ADDENDUM 2

Vestavia Hill Fire Station No. 4 Expansion

DATE: **August 12, 2026**

01 HIGH POWER AMPLIFIER AND INTERIOR SPEAKER
N.T.S.
RE: WESTNET SPECIFICATIONS FOR OVERALL DEVICE DIMENSIONS.

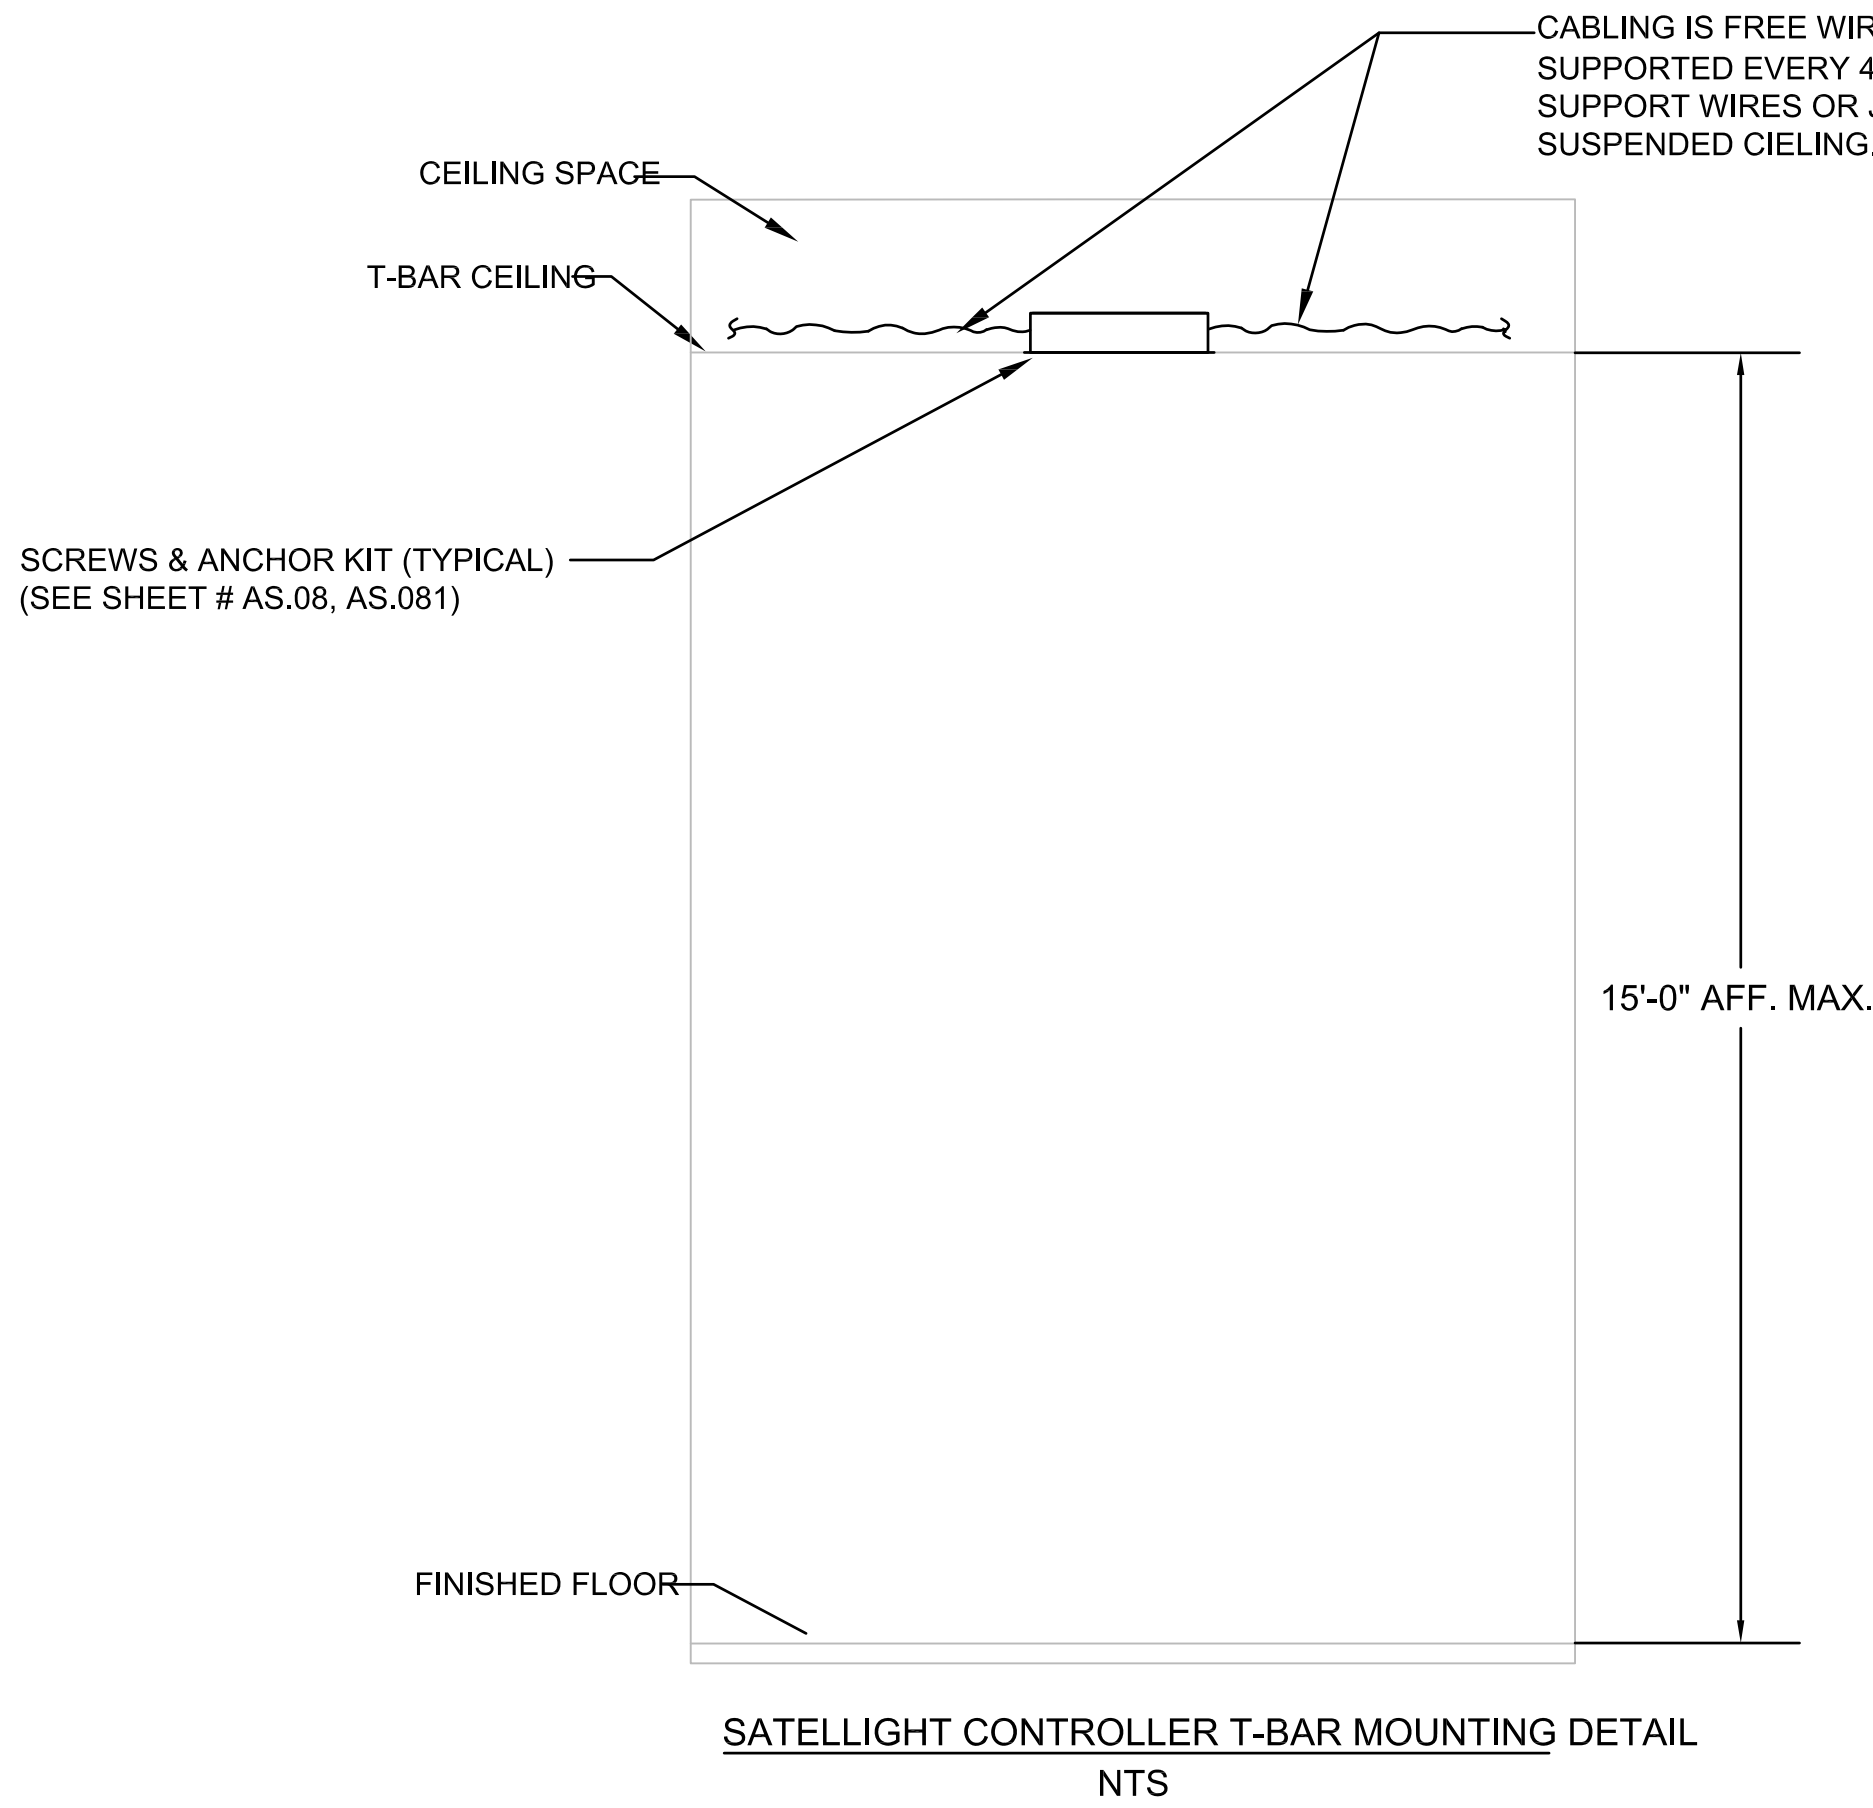
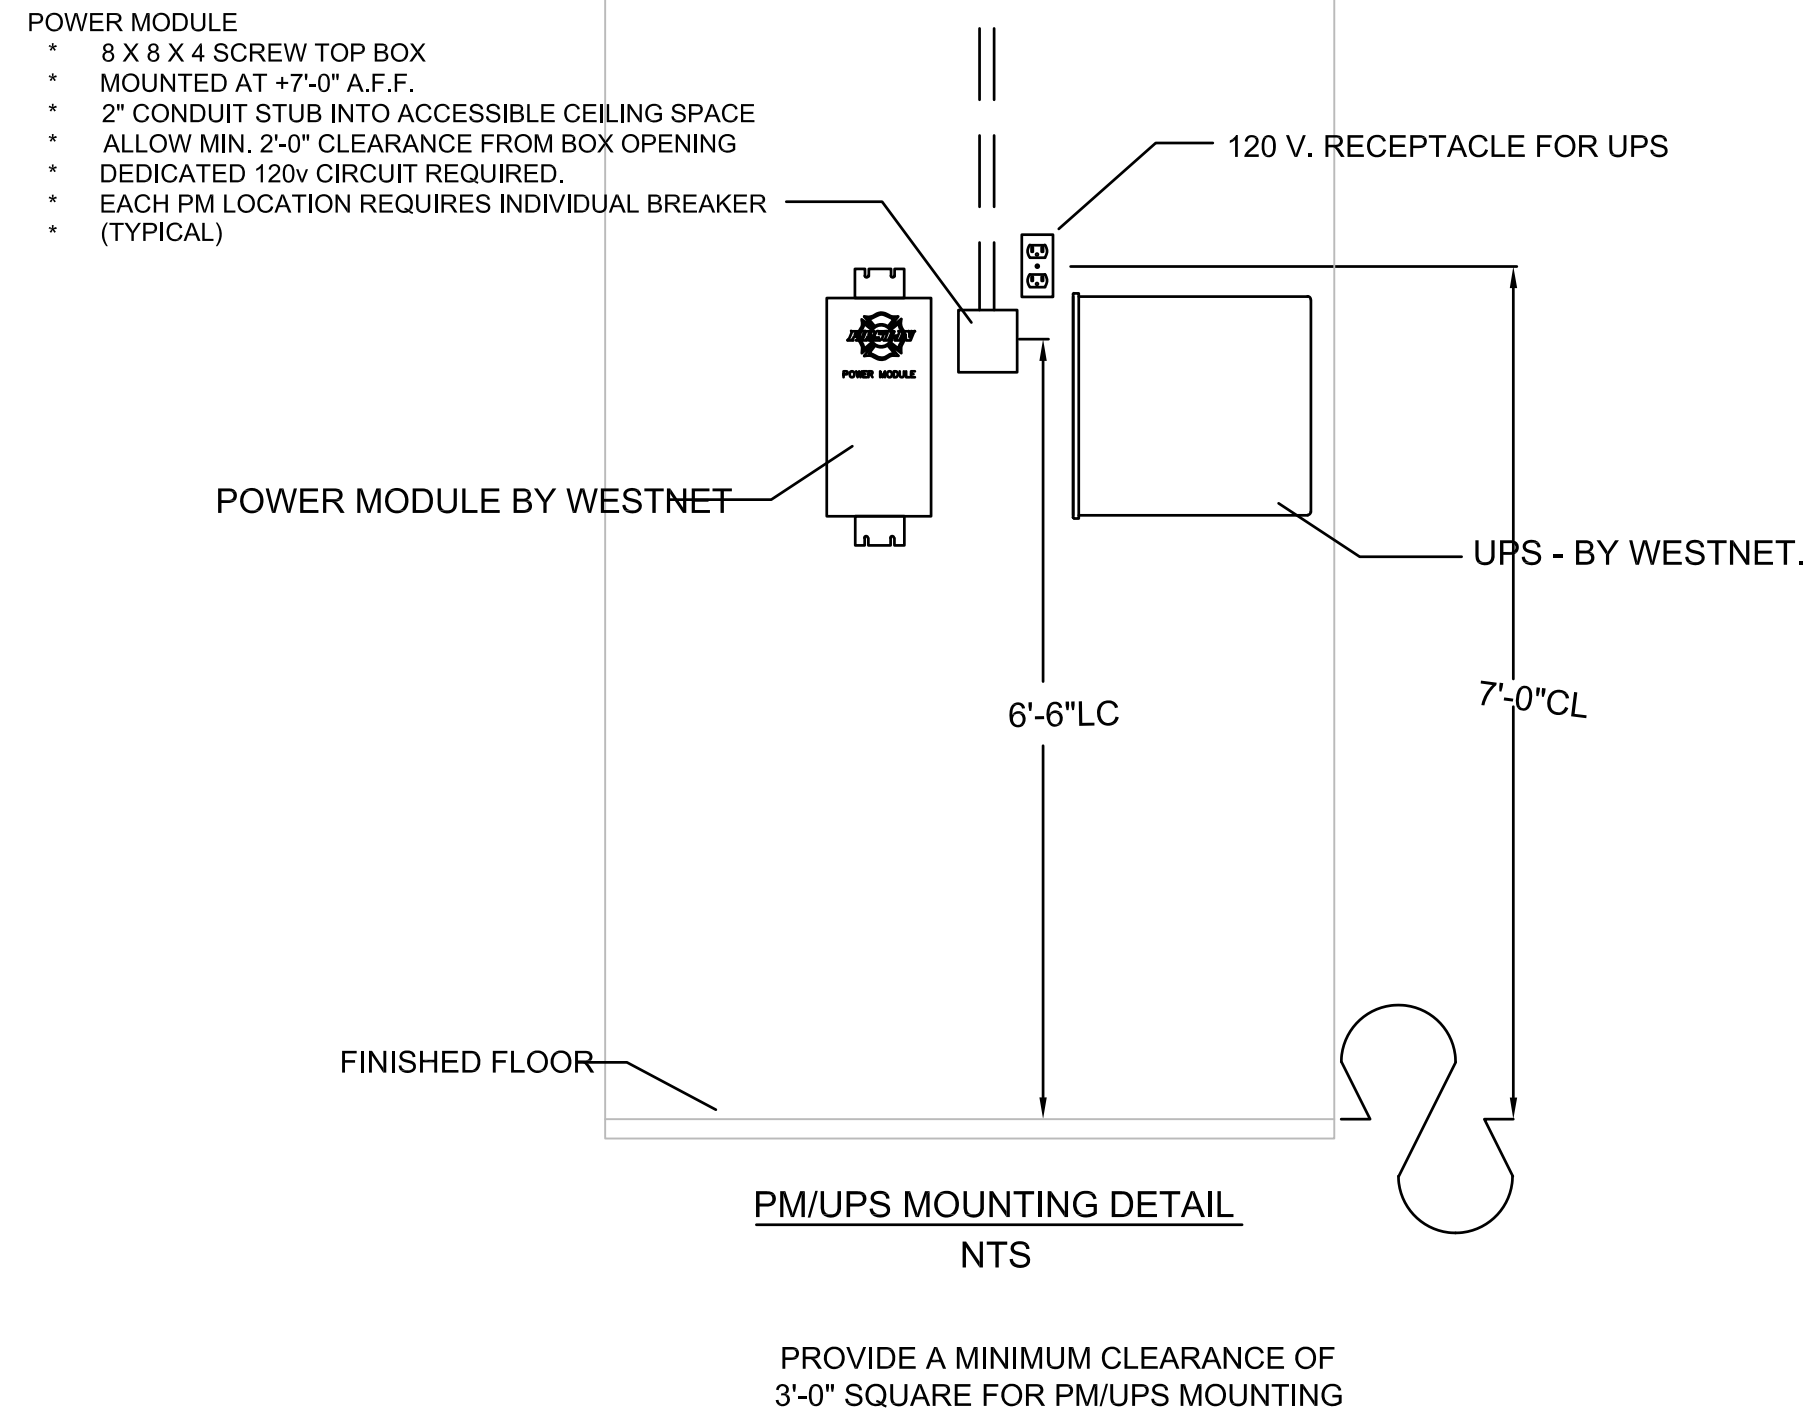
12. E-604 – ALERT SYSTEM DETAILS:
 - a. Added drawing for alert system details to coordinate with Alert System Shop Drawings.
